B-20-0741 CITY OF PUYALLUP

Customer:
10-Phone Quote - PPTC100
Job Name:
Farris Residence
Job Number:
J1060421F

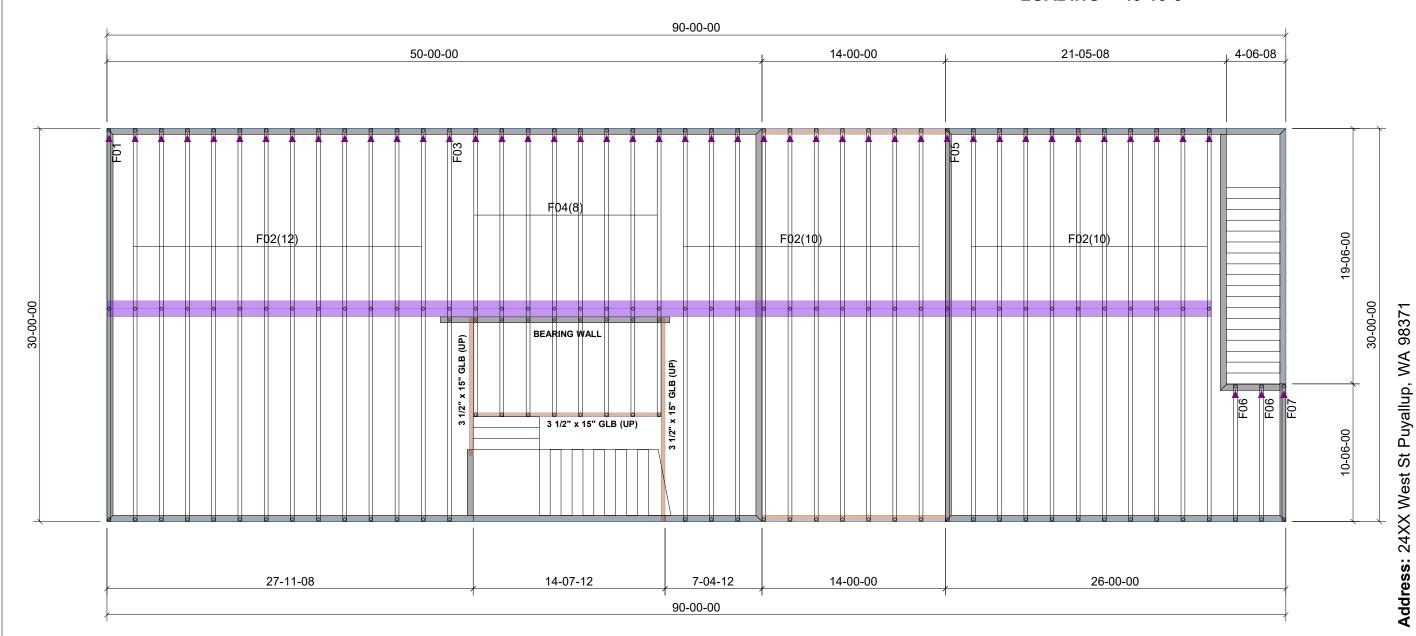
PLANS CALLED OUT FOR TRUSSES TO BE 16" DEEP AT 24" O.C.

TRUSSES DO NOT WORK UNDER THOSE CRITERIAS

FLOOR TRUSS DEPTH = 24" SPACING = 24" O.C. LOADING = 40-10-5
